Class II Permissive Change Letter

FCC ID: KA2WA140B2 IC: 4216A-WA1401

Date: 2010/6/3

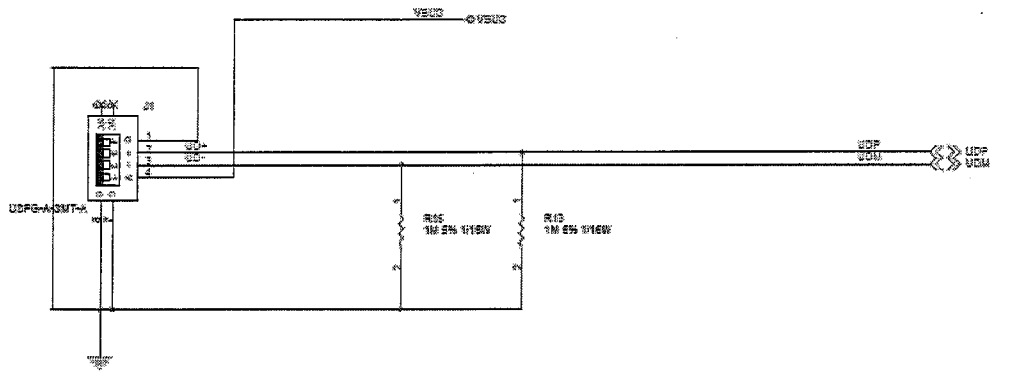
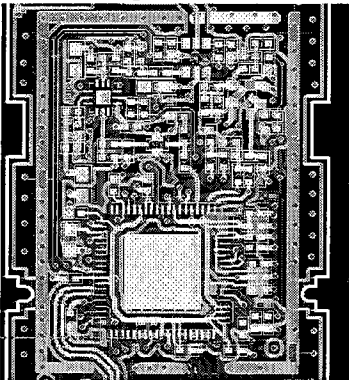
- 1, Remove R17 component (0ohm resistance)

Reason: It's the purpose for RD to measure the power consumption only, the component has no function here, so we remove it..

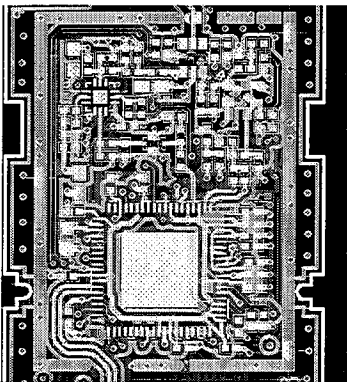
2, Modify PAD of shielding frame as below
Original:
